Great White Kaolin Project

Mining Proposal and Miscellaneous Purposes Licence Management Plans

RESPONSE DOCUMENT

July 2021

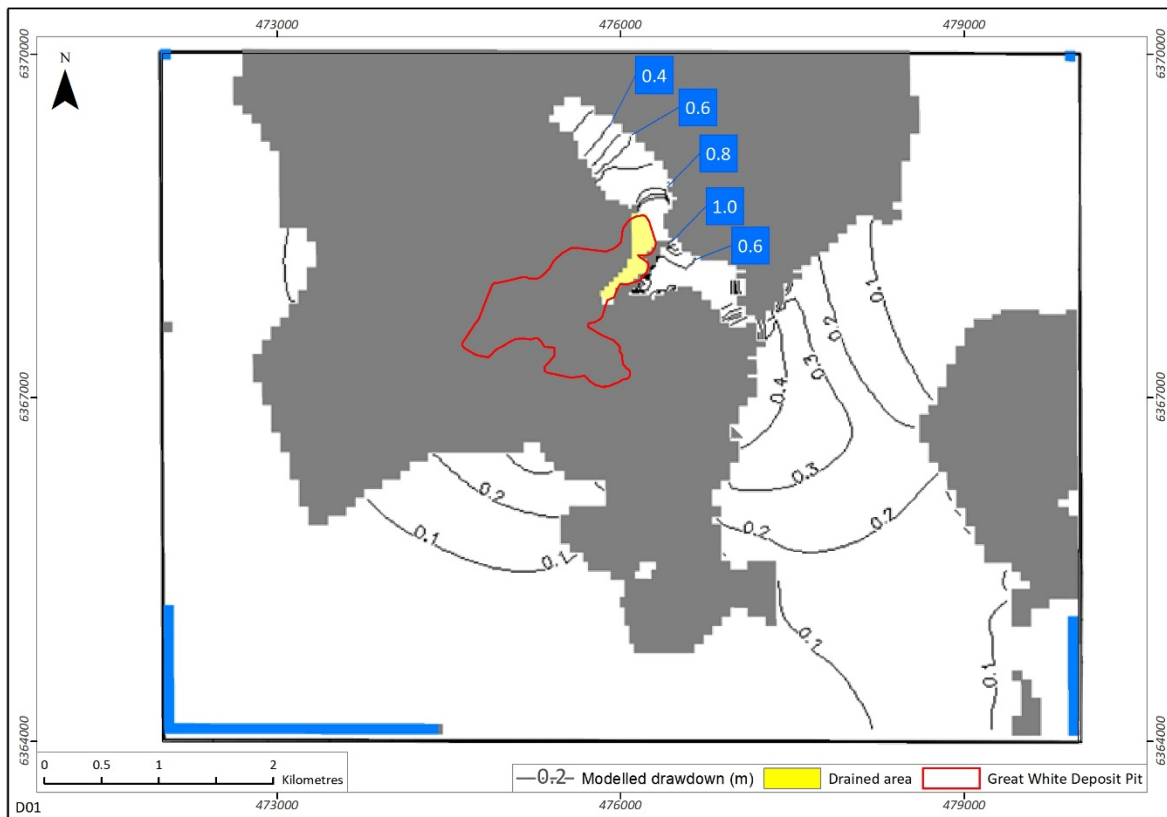
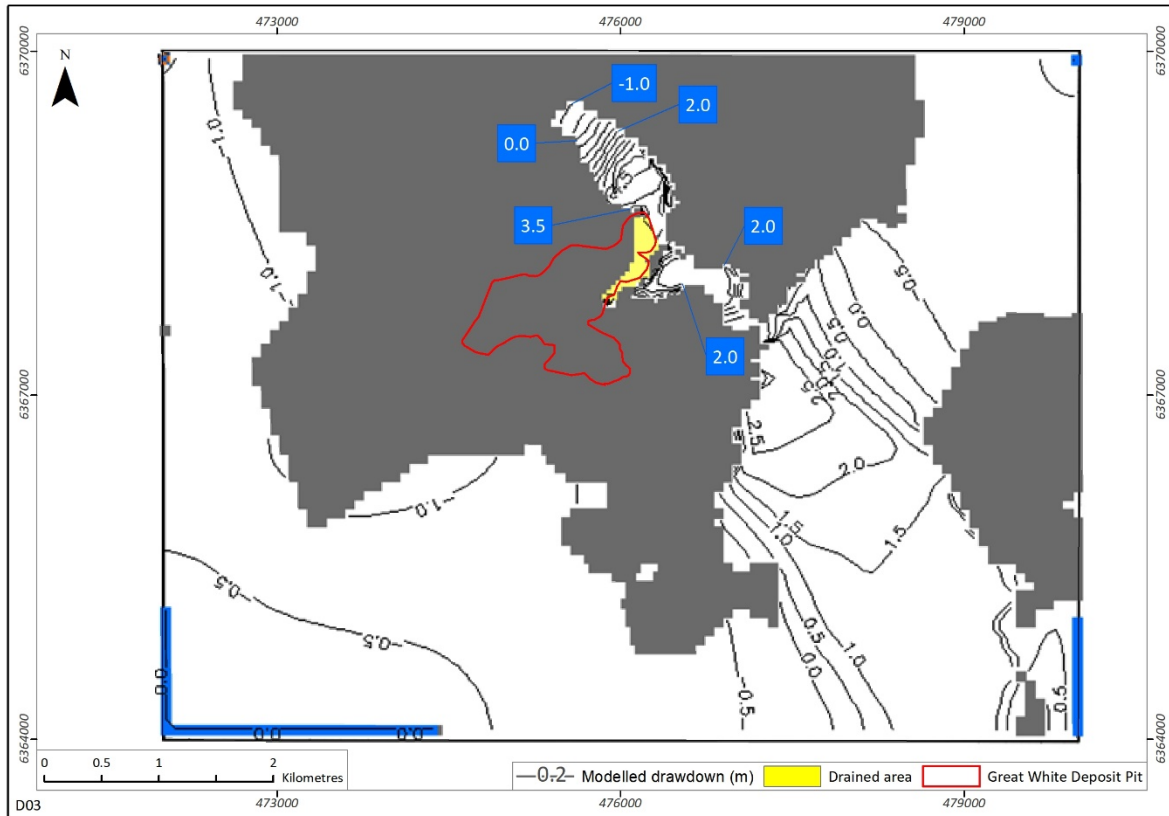
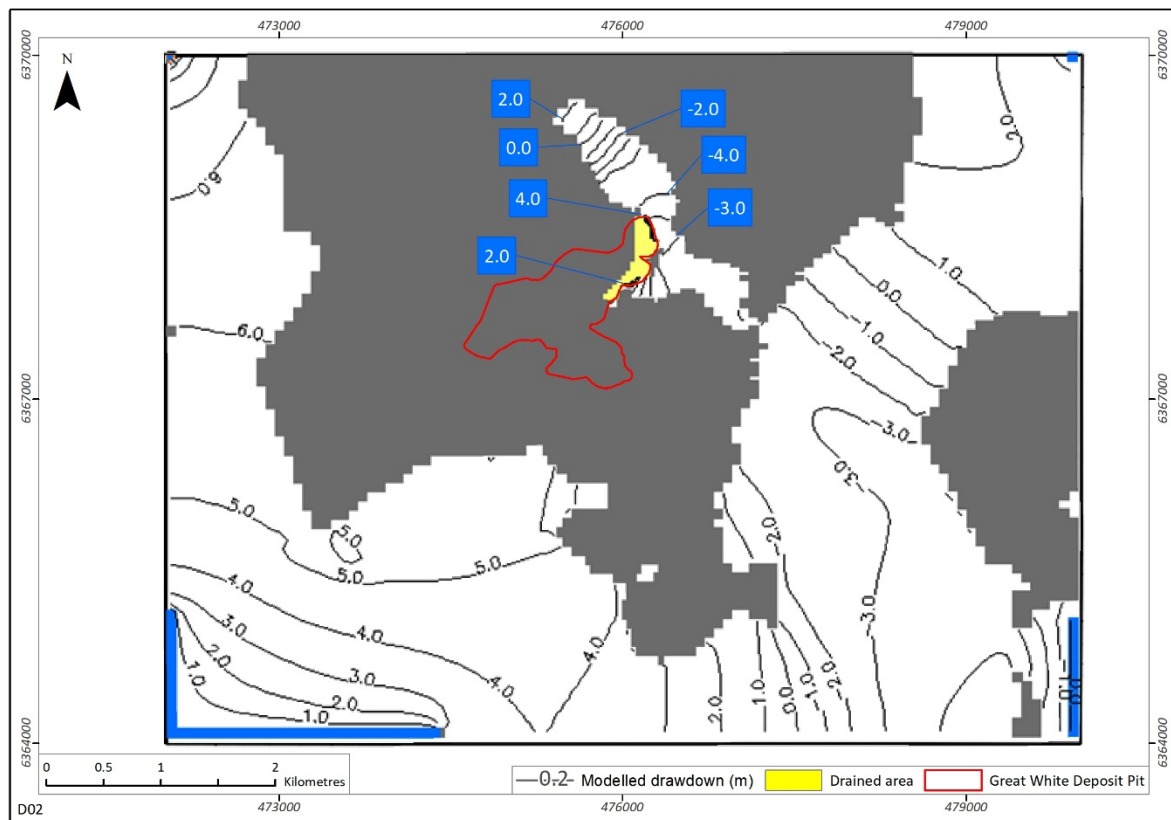
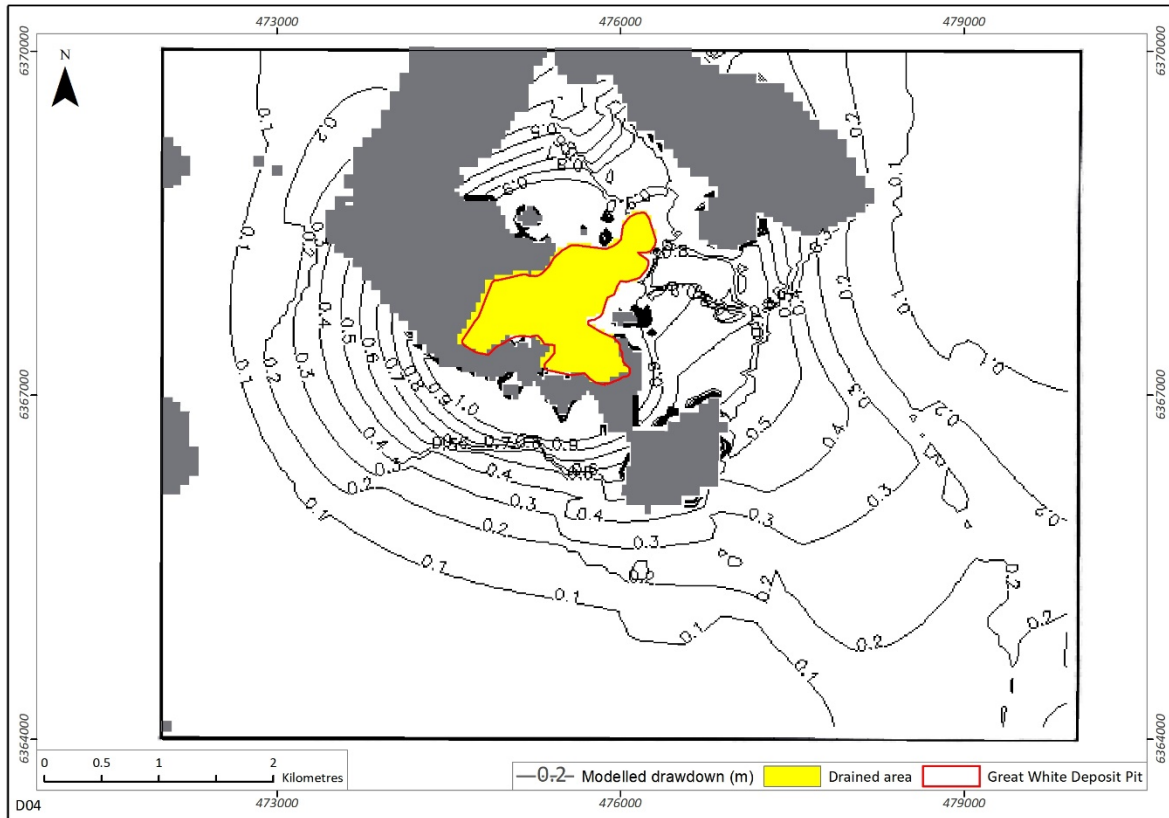
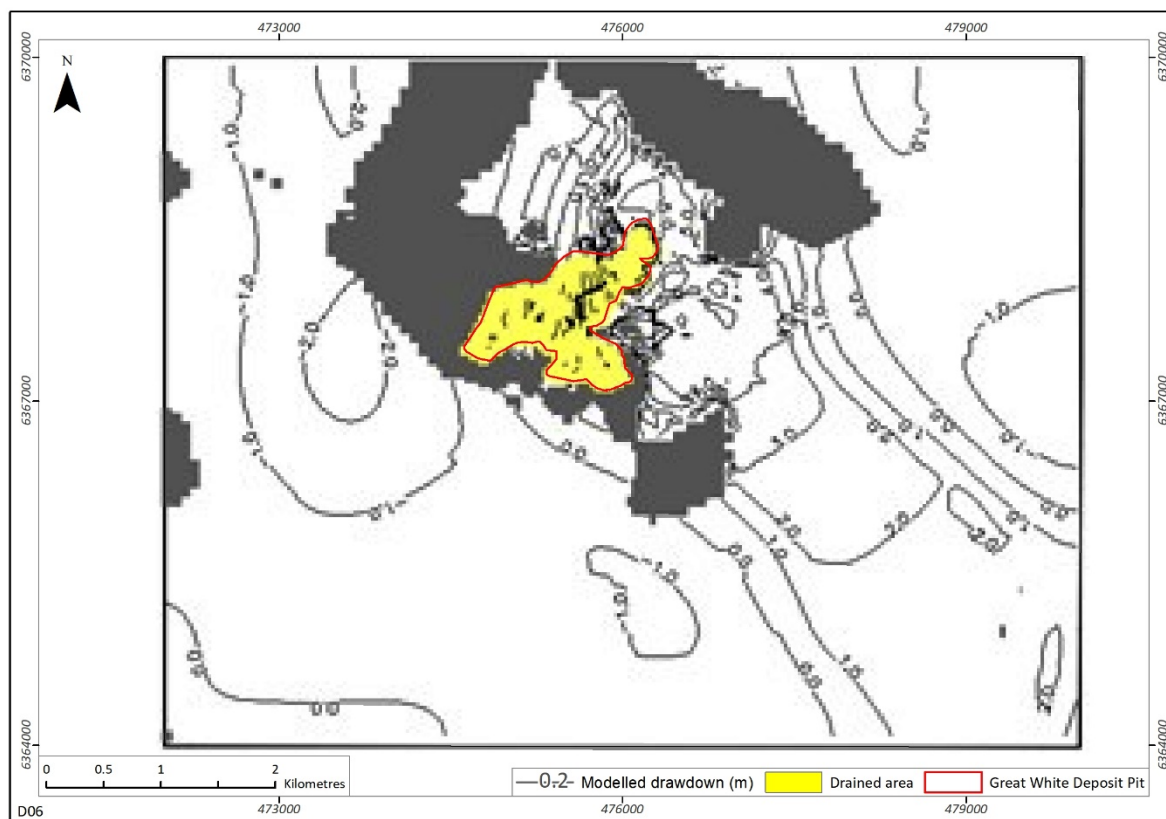
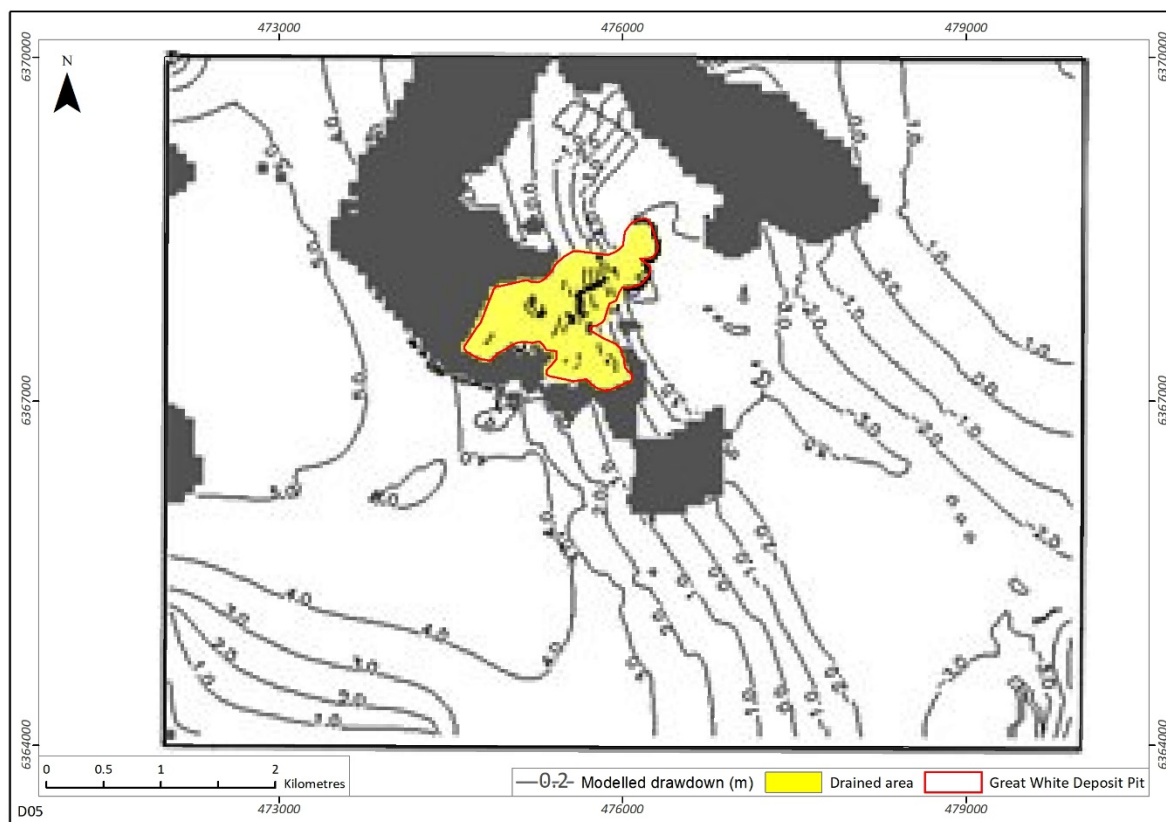
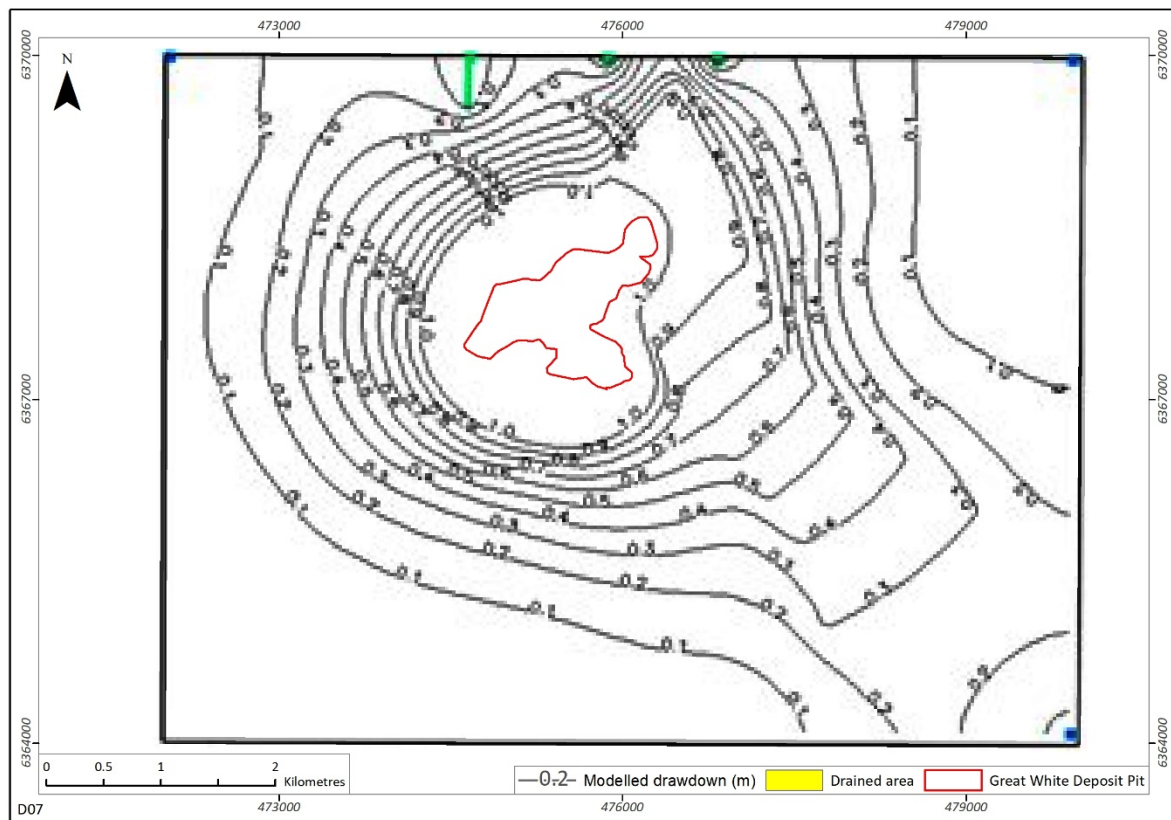
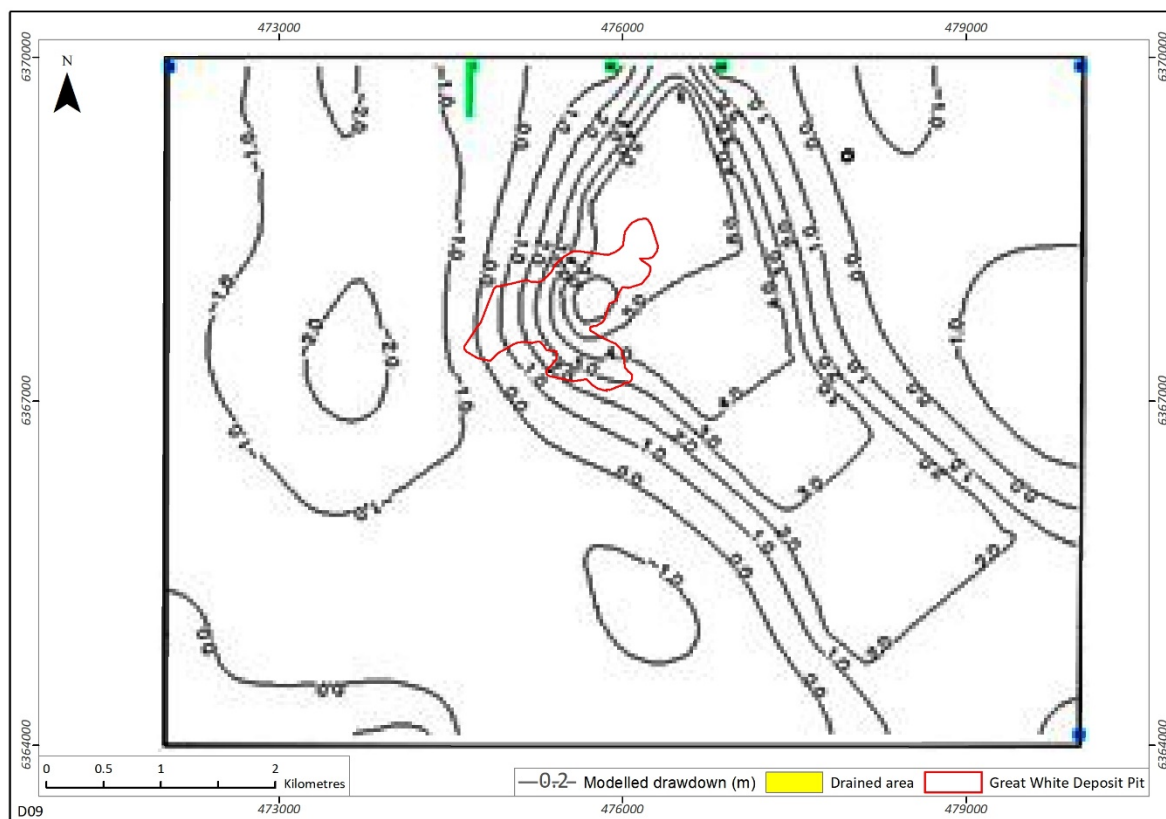
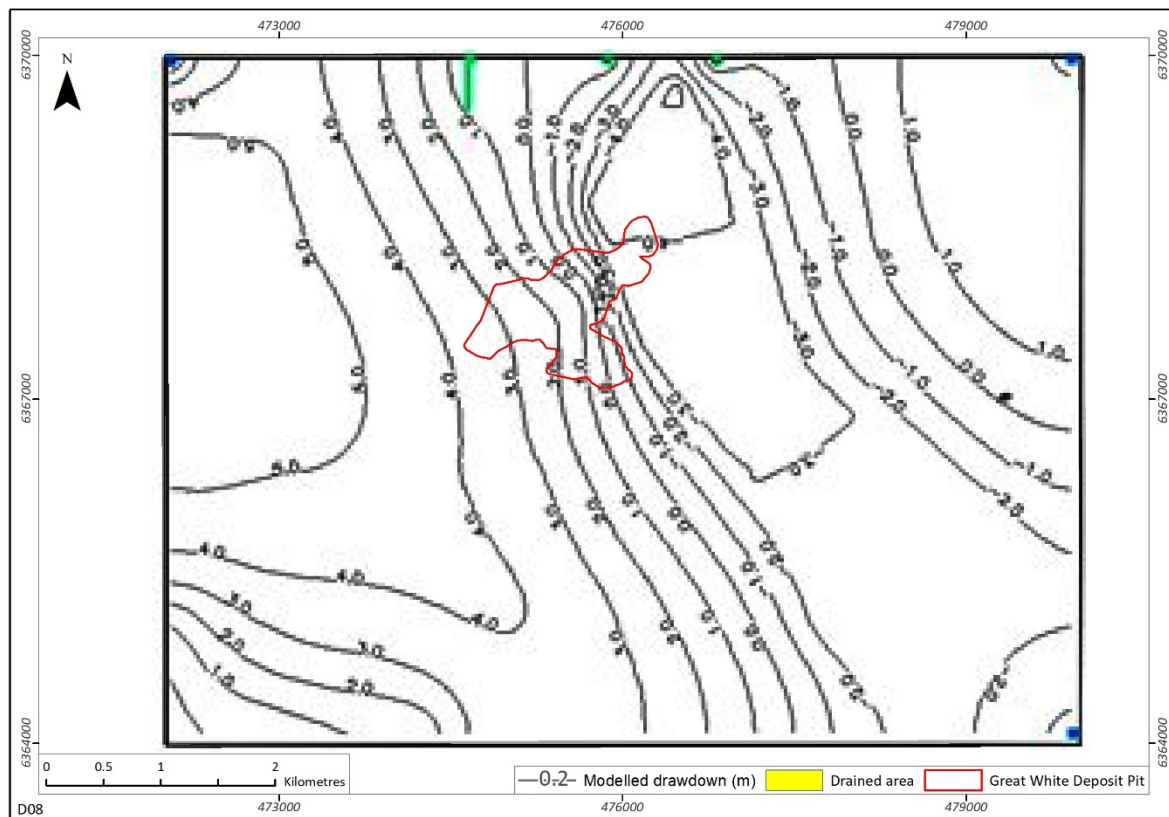
#	Reference	Comment	Further Information or Clarification Required	The Company's Response
		alternative conceptualisation that describes the kaolinised granite as a leaky aquitard is also supportable. There is currently no uncertainty or sensitivity analysis within presented modelling to determine whether such alternative conceptualisations present any variance in risk profile.		Agree that a leaky aquitard is possible, and a sensitivity analysis has been carried out on kv and kh for the kaolinised granite layer 2 (Appendix H).
33	Section 2.6.1, figure 1-18; Section 3.8, figure 3-13; Appendix J, Section 5.6, figure 36.	The conceptual block diagrams throughout the document do not clearly indicate the following observations concerning the hydrogeology of the site a) The Garford Formation for the most part is unsaturated ("dry"), with only a small portion with any notable permanent saturation found near the northern corner of the pit. b) The water table level in the cross-sectional view of the block diagram. c) Based on Comment 3 an acknowledgement of possible limited communication through the kaolinised granite Likewise, acknowledgement recharge could be localised through dissolution features in the Bridgewater Formation calcrete sheet horizons.	Review and update relevant diagrams.	Figures 36 and 37 both show the SWL, where the Garford Formation is below this line it is saturated. The schematic could be altered to include saturation in part of the Garford Formation. Vertical arrows could be included to indicate (limited) vertical movement of infiltrating water. Site investigations by the Company indicate that sheet calcrete occurs in some parts of the Bridgewater Formation but not everywhere. Where calcrete has been exposed, it is often rubbly and nodular and in areas where hard calcrete has been exposed in the sides of excavations, it is regularly jointed with joint spacings of less than 1 m (refer Appendix H, Attachments 2 to 4). There is no evidence on site to suggest that the Bridgewater Formation includes large (model cell sized or greater) areas of impermeable calcrete capping. Dissolution features have been observed but are small and along with jointing, occur at spacings of less than 1 m to several metres. Given the model cell sizes range from 40 m x 40 m to 80 m x 80 m, we consider the matrix of joints cracks and dissolution features to be uniformly and sufficiently closely spaced for the recharge through the Bridgewater Formation to occur uniformly across the model domain.
